ADMINISTRATIVE AMENDMENT	
FILE #:	PROJECT #:
APPROVED BY	DATE

NEW OFFICE/RETAIL 9001 HOLLY AVENUE, NE ALBUQUERQUE, NM PARAMOUNT REALTY TATE FISHBURN ARCHITECT LEGAL DESCRIPTION: NORTH ALB. ACRES TRACT 3 UNIT 3 BLOCK 19 LOT D CURRENT ZONING CLASSIFICATION: TYPE II B

SITE DEVELOPMENT PLAN FOR BUILDING **PERMIT**

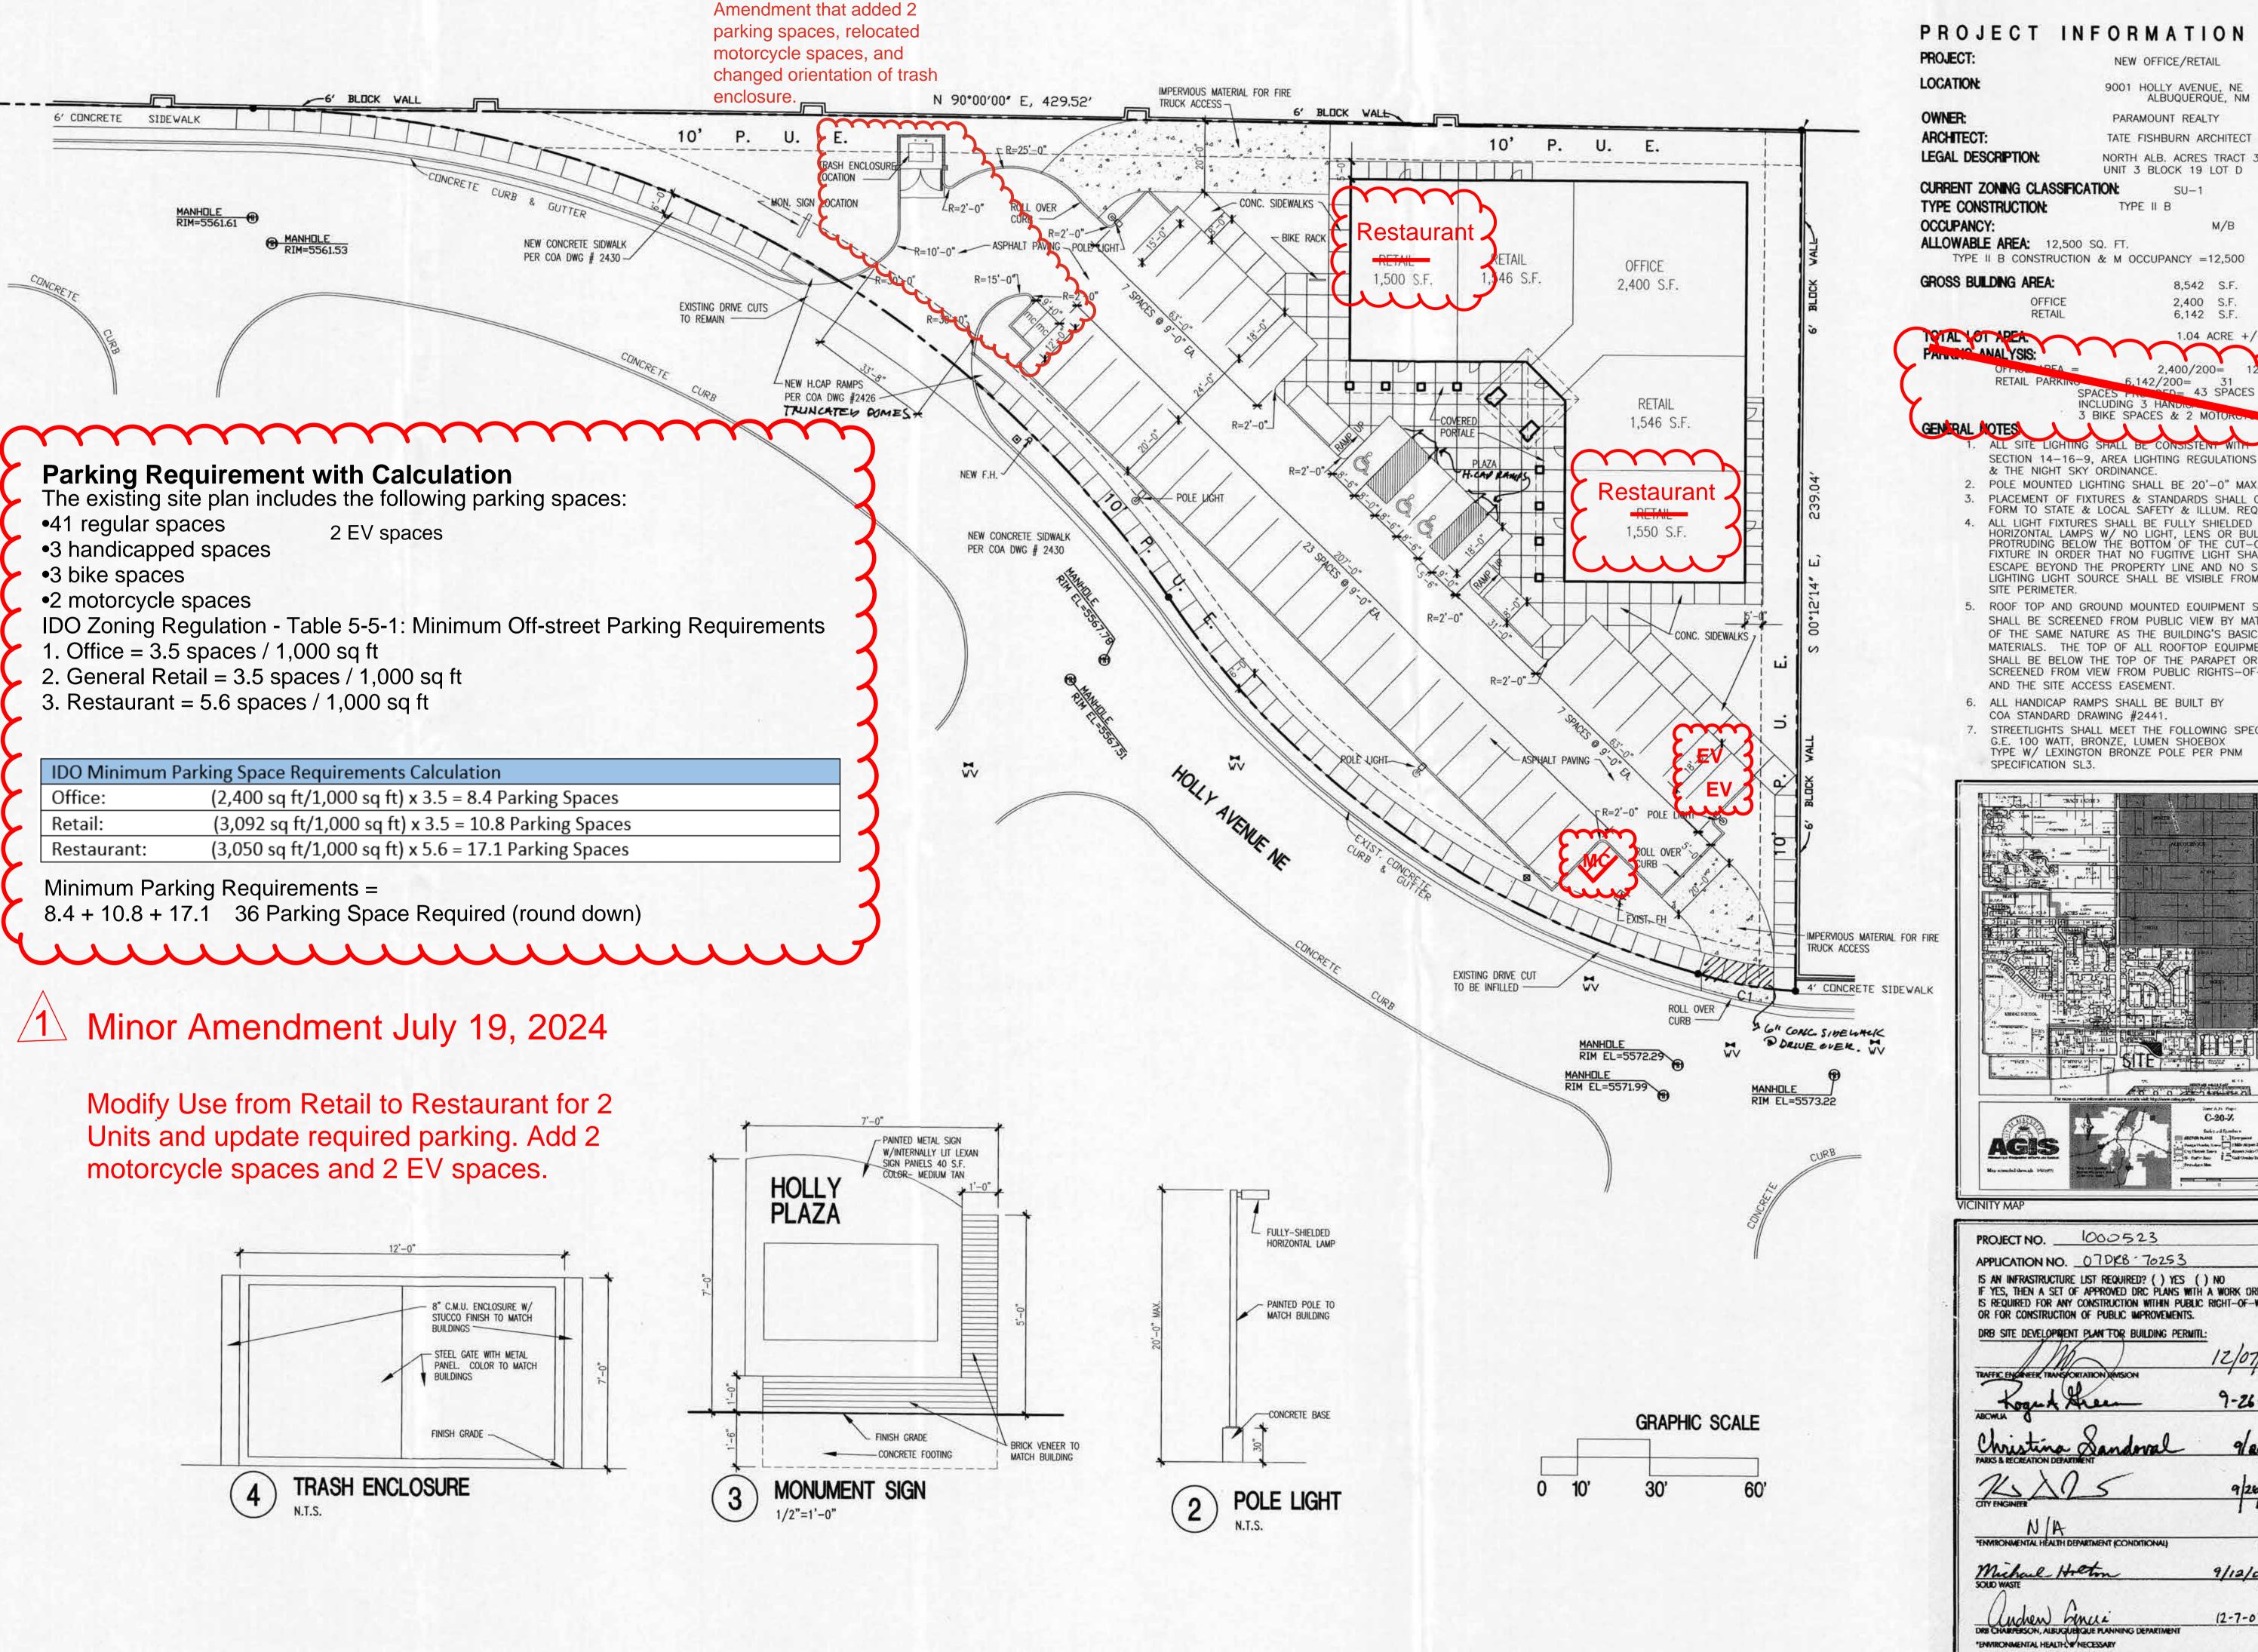
Hydrology Condition of Approval:

Developer must install a waterblock to control the runoff to or from the dumpster area.
